M e m o r a n d u m

Subject: Hydrologic and Biologic Review of THP 1-18-095 MEN

This memorandum reports the results of a focused Pre-Harvest Inspection (PHI) for the Little THP (1-18-095 MEN). Field inspection participants for the PHI held on August 29, 2019 included the following individuals:

Figure 3. Relative elevation map of Reach 1 of the Little North Fork of the Gualala River. Numbers refer to sites assessed in the O'Connor channel migration zone evaluation (OCE, 2019a). Arrows represent potential flowpaths evaluated in the field.

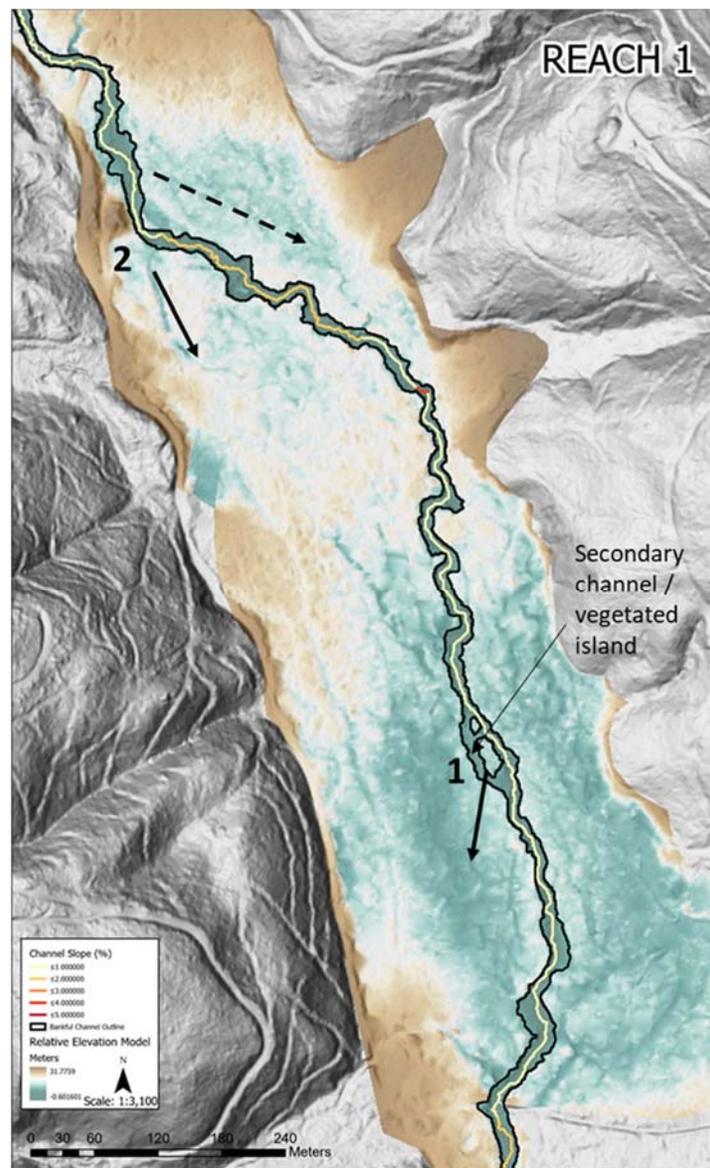
Site 1 is within Reach 1 at the lower end of the Little North Fork of the Gualala River and is shown in Figure 3. Dr. O'Connor identified and evaluated Site 1 based on concerns by CDFW that the area was subject to potential avulsion from the Little North Fork of the Gualala River. The relative elevation model confirms the presence of potential overbank flooding in the vicinity. However, the relative elevation model indicates that this flooding is generally dispersed rather than concentrated into channelized flowpaths.

Dr. O'Connor noted the presence of secondary channels that create small vegetated islands upstream of Site 1, and noted it as a form of small scale channel migration that is characteristic throughout the Little North Fork Gualala River. He also suggested that the secondary channel be given Class I watercourse protection. Dr. O'Connor noted that a right-bank² linear to curvilinear swale was present down gradient of the secondary channel (Figure 4), but stated that the flowpath was distributary in nature and did not reconnect with the primary channel. He concluded that the swale did not have the erosive power to create a new primary/secondary channel. CAL FIRE WPP staff observations were consistent with those noted by Dr. O'Connor. Avulsion potential is greatly increased when the floodplain flowpath gradient is 3-5 times greater than that of the primary/secondary channel (WFPB, 2004). Staff measured the slope of the secondary channel and swale feature and found them to be approximately equal ($\approx 1\%$), indicating a relatively low potential for avulsion.

The observations and rationale provided by Dr. O'Connor were confirmed by CAL FIRE WPP staff. Staff determined the water surface elevation would have to rise by 5-6 feet (Figure 5) before it would access the right-bank floodplain feature. The 20-year recurrence interval storm is predicted to overtop this feature (OCE, 2019a), but did not show signs of recent overtopping. The slope of the floodplain feature was approximately three times greater than that of the primary channel (1.5% vs. 6%). However, the steeper surface only persisted for approximately 100 feet before flattening to a gentler slope. The feature does have characteristics that indicate it might have been a skid trail at one time, as the soil appeared compacted and had the same approximate width of a skid trail. The relative elevation model shows strong evidence that the feature acts more as a flooding and depositional flowpath rather than as a potential avulsion pathway. Staff also noted the presence of the left-bank overflow floodplain feature noted in Dr. O'Connor's report, and this is expected to convey most of the overbank flow, rather than the right-bank feature, during a storm event.

Figure 6. Relative elevation model of Reach 2 of the Little North Fork of the Gualala River. Numbers refer to sites assessed in the O'Connor channel migration zone evaluation. Alphabetical designations represent areas with secondary channel or potential secondary channels.

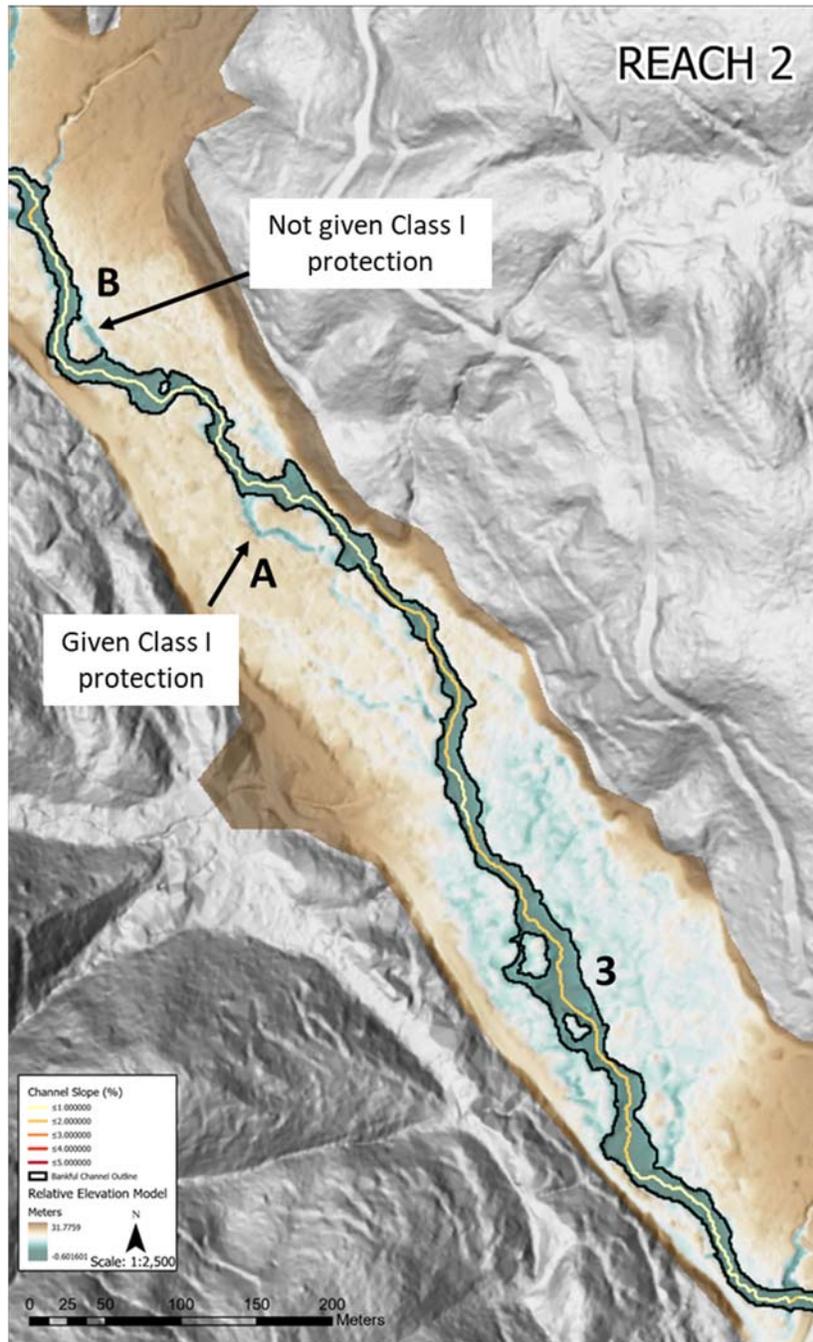
The relative elevation model indicates two locations upstream of Site 3 that showed similar signs of secondary channel development. Site A (Figure 6) indicates the presence of a possible secondary channel. Revised silviculture maps submitted by the plan proponent indicate this feature has proposed Class I watercourse protection. Site B (Figure 6) shows another location along the Little North Fork of the Gualala River where a secondary channel may also be present. The revised silviculture maps indicate that this potential secondary channel has not been given Class I watercourse protection. It was also not evaluated by Dr. O'Connor in his report. As a result, we suggest that this area be evaluated for the presence of a secondary channel, and the need for Class I watercourse protection (**Recommendation 1**).

For Reach 2-B identified in Figure 6, the RPF is to further evaluate the site for the presence of a secondary channel, and apply Class I watercourse protection standards if appropriate.

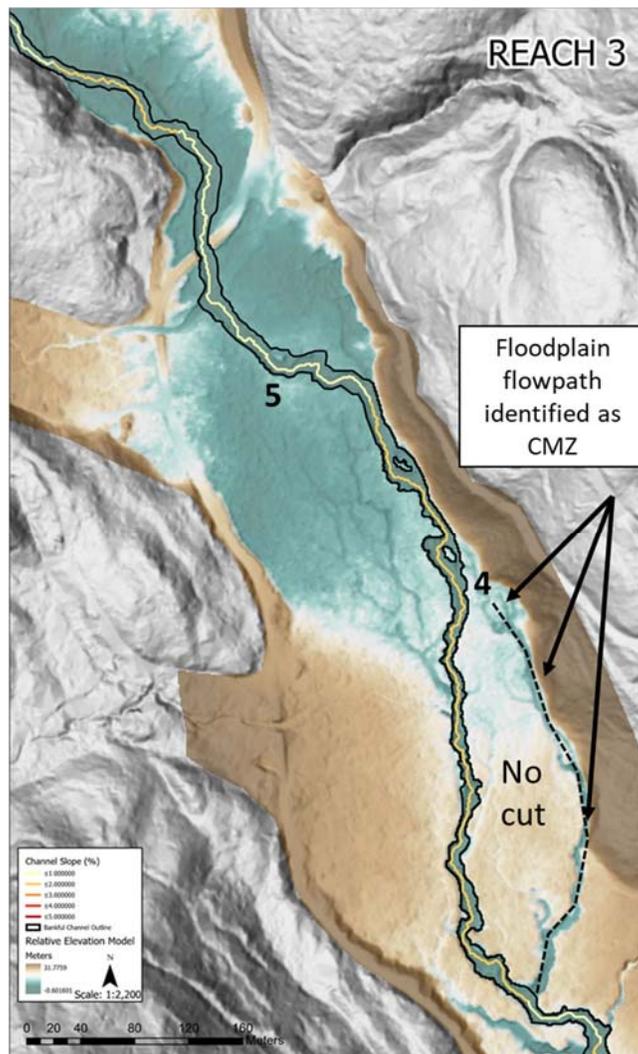
Site 4 is within Reach 3 and is shown in Figure 8. Dr. O'Connor identified and evaluated Site 4 because it is a left-bank flowpath that was predicted to have flow with the hydraulic modeling study (OCE, 2019b). The relative elevation model shows clear evidence of a defined flowpath on the left bank that has potential upstream and downstream connectivity with the primary channel. Dr. O'Connor identified this area as possibly being influenced by an old road with a high likelihood of avulsion, and identified the area as channel migration zone for approximately 1000 feet. Additionally, red alder stands were evident in this area using the 1988 aerial photos. The area between the left-bank flowpath and the primary channel fits the criteria of an Avulsion Hazard Zone.

CAL FIRE WPP staff agree with this assessment. Staff noted that the upstream end of this flowpath is approximately three feet higher than the existing channel, and is located within a bend in the channel with a large woody debris jam directly downstream. Form roughness in combination with in-channel large woody debris roughness (Figure 9) has the potential to cause a rise in water surface elevation which could shift the main flow to this left-bank flowpath.

Figure 10. Evidence of abrasion on the base of a snag illustrating floodplain depths can reach two feet above the bankfull elevation (red line).

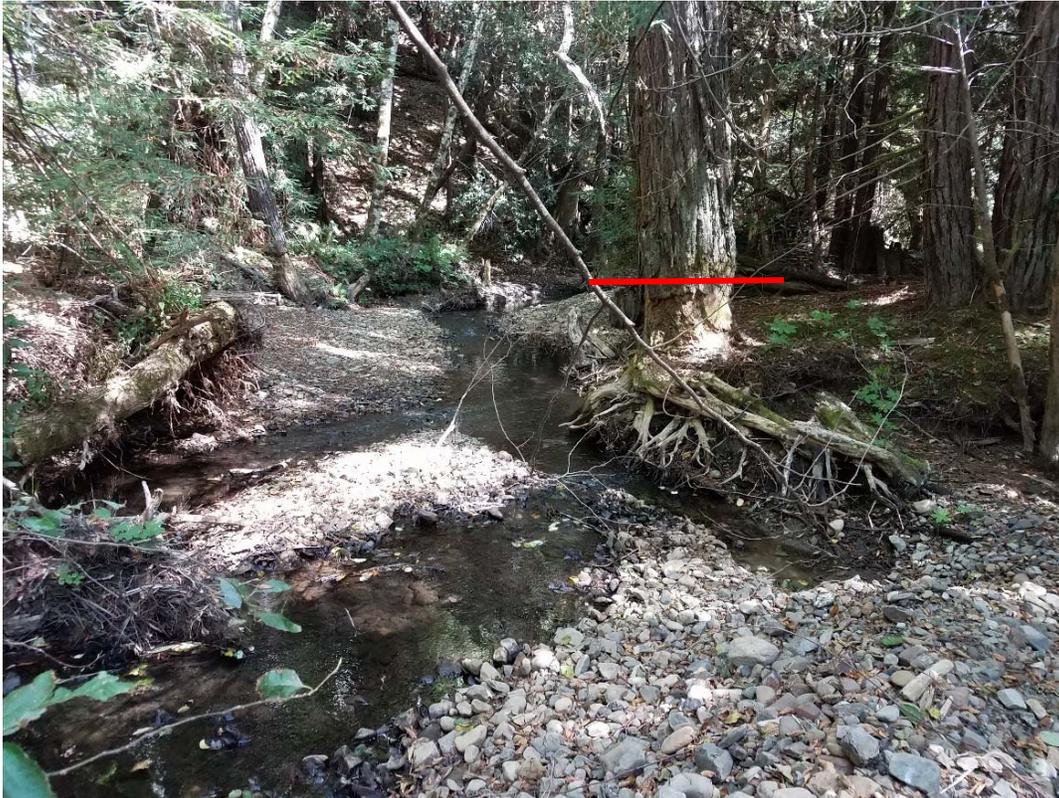
CAL FIRE WPP staff agree with the assessment provided by Dr. O'Connor. Evidence of abrasion on the base of snags showed that floodplain depths can reach two feet above the bankfull elevation (Figure 10). There was no evidence of abandoned channels that could act as potential avulsion flowpaths.

Figure 11. The relative elevation model for Reach 4. The number refers to the site assessed in the O'Connor channel migration zone evaluation (Site 6).

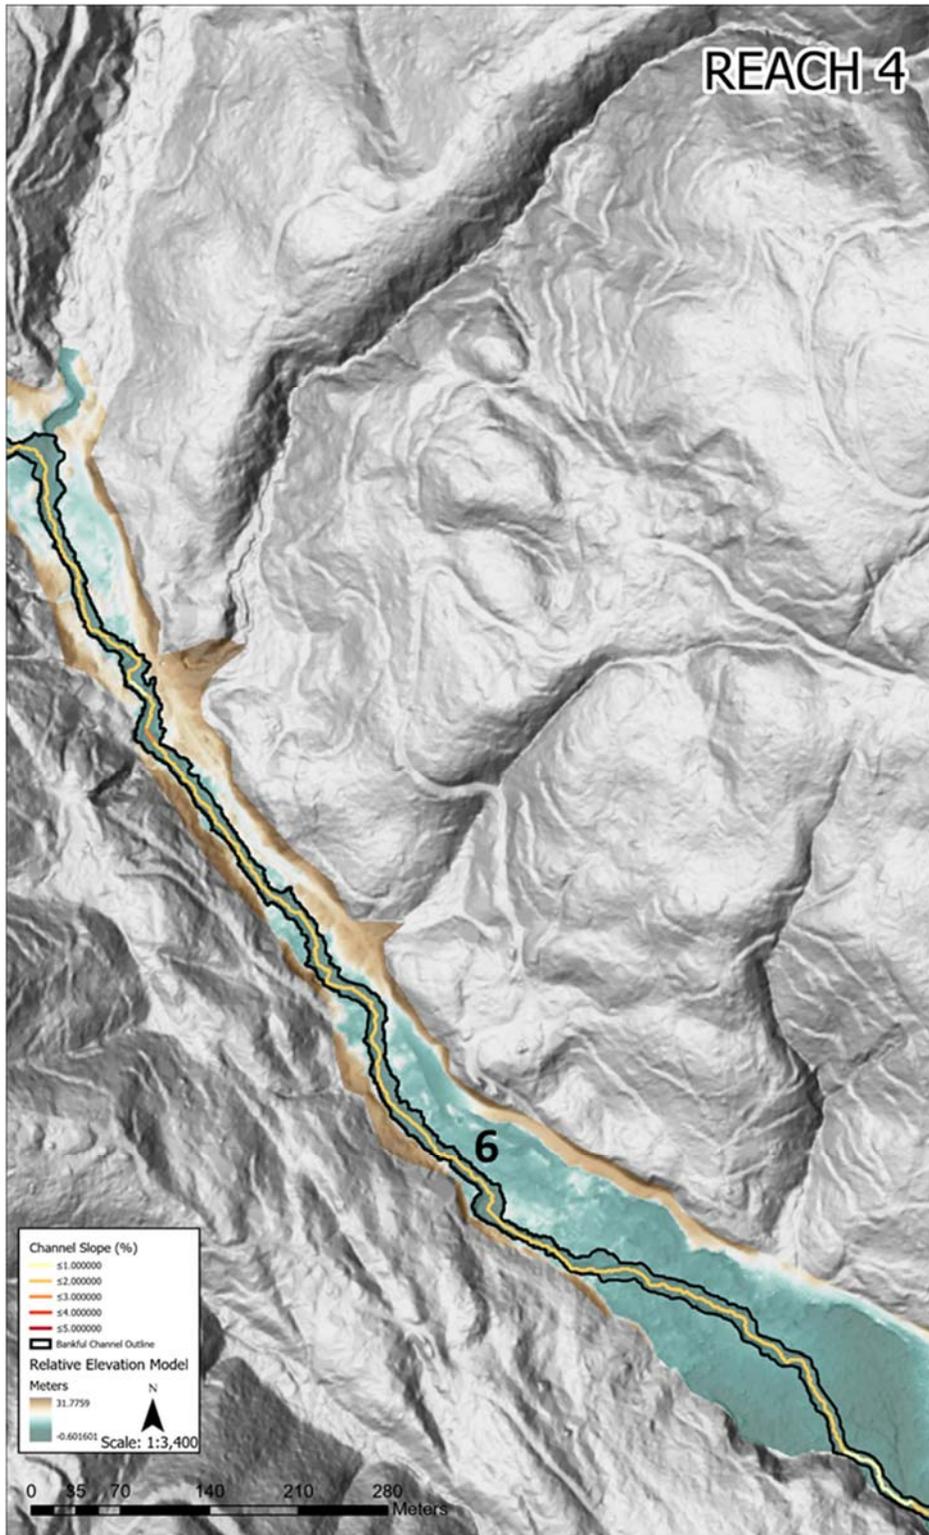
Site 6 was investigated by Dr. O'Connor due to the potential presence of secondary channels as indicated by the hydraulic model simulation (OCE, 2019b). The relative elevation model (Figure 11) indicates the potential for extensive overbank flooding near Site 6. In his report, Dr. O'Connor mentioned the presence of a landslide that impinged on the Little North Fork of the Gualala River, with the potential to cause the channel to shift its position (OCE, 2019a). However, he concluded that the landslide did not trigger an avulsion of the Little North Fork of the Gualala River. Dr. O'Connor concluded that the area is not a channel migration zone.

CAL FIRE WPP staff agree with the Dr. O'Connor's assessment. Staff noted silt lines of approximately 1.7 feet on the floodplain. However, there were no signs of abandoned channels in this area. Staff noted an area of bank erosion at a small bend in the Little North Fork of the Gualala River, but it appears relatively stable as the relative elevation model shows no signs of lateral erosion (e.g., meander scrolls) nearby. A clump of large redwood trees tipped into the channel during the winter of 2018-2019 here but has not caused channel movement (Figure 12).

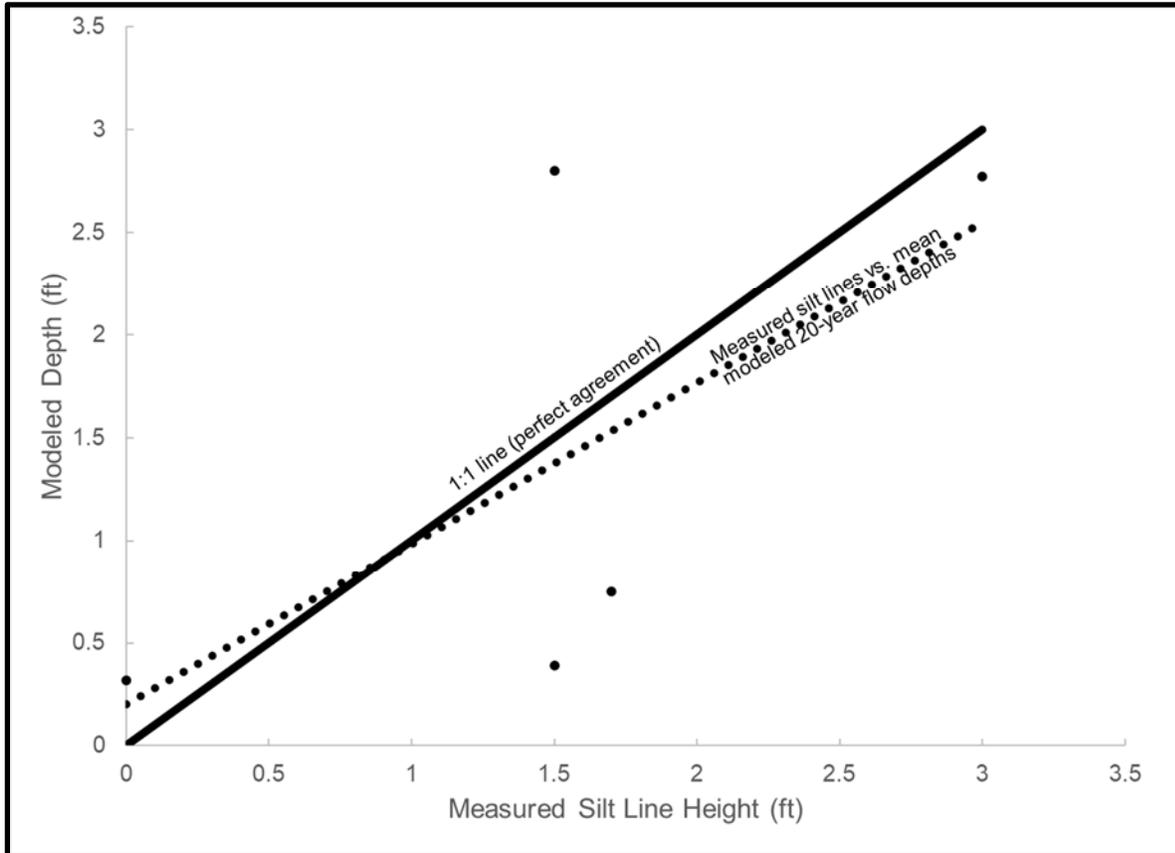
During the focused PHI, CAL FIRE WPP staff compared measured silt lines on trees to the water depth predicted by hydraulic model simulations using the Collector/Avenza applications on iPads. Due to accuracy of the iPad GPS under tree canopy, locations had potential errors ranging from approximately 15-40 feet. Because of this potential error, we averaged flow depths within a 20-foot radius of the measurement point. A linear regression between measured silt height and average modeled flow depth was

not significant. However, the regression line is relatively close to a 1:1 relationship (Figure 16).
